SUBSURFACE WASTEWATER DISPOSAL SYSTEM APPLICATION

Town/City/Plantation
PORTLAND, PEAKS ISLAND

Street/Road/Subdivision
EVERGREEN AVENUE

Owner's Name
GUS FILIPOS

SUBSURFACE WASTEWATER DISPOSAL PLAN

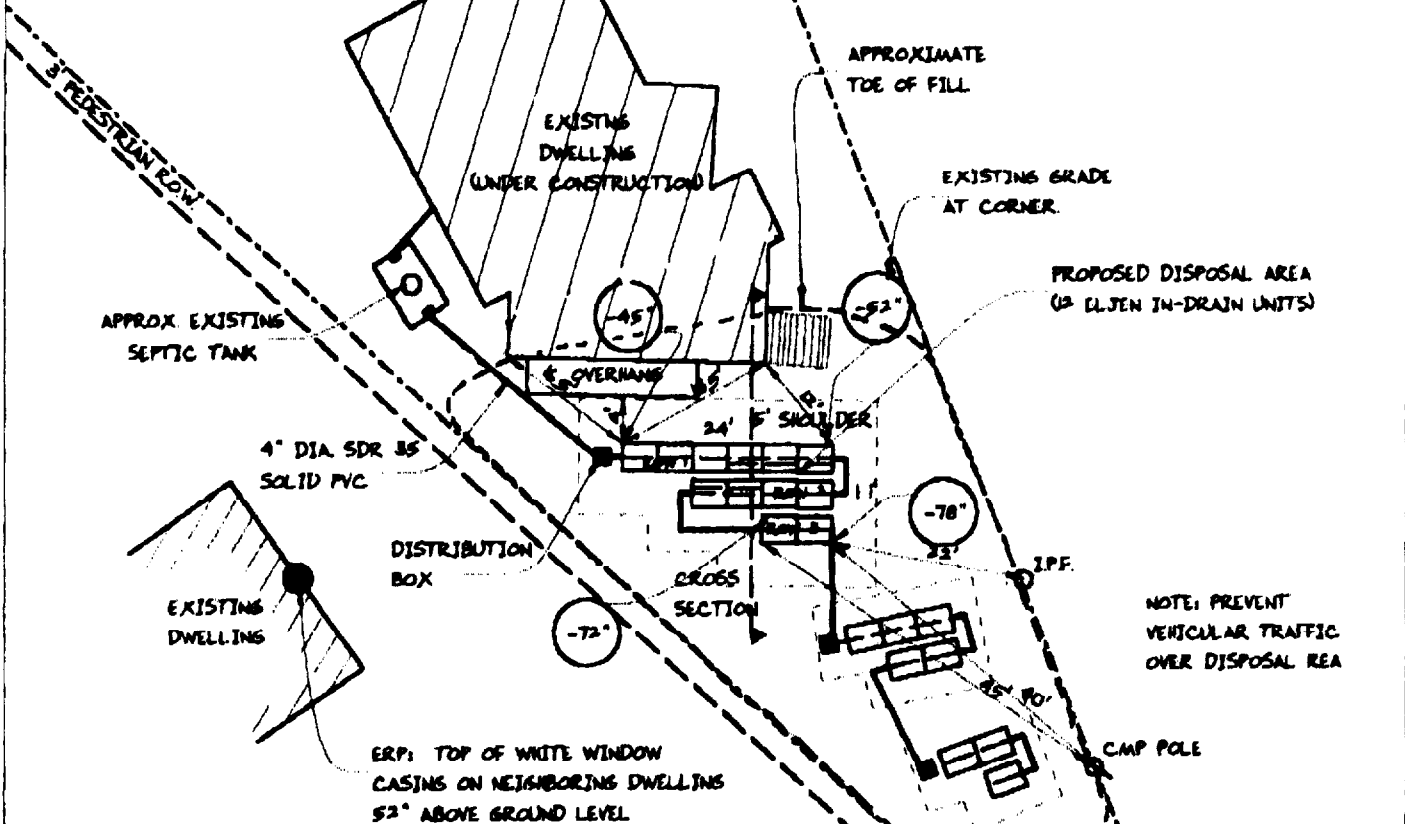
10/19/01 New plan submitted, Top
bed installed measurements per
new plan correct, correct # of
Eljen Unit properly install. OK to
backfill (medium sand). Property owner
had new plan for my review & inspection.
Spoke with Matt Logan by phone &
reviewed new plan with onsite
installation. Top bed installed correctly.

10-25-01 checked middle & lower beds
OK to close Eljen system check
V-BX & piping overlaps & coated
units properly installed
AMW
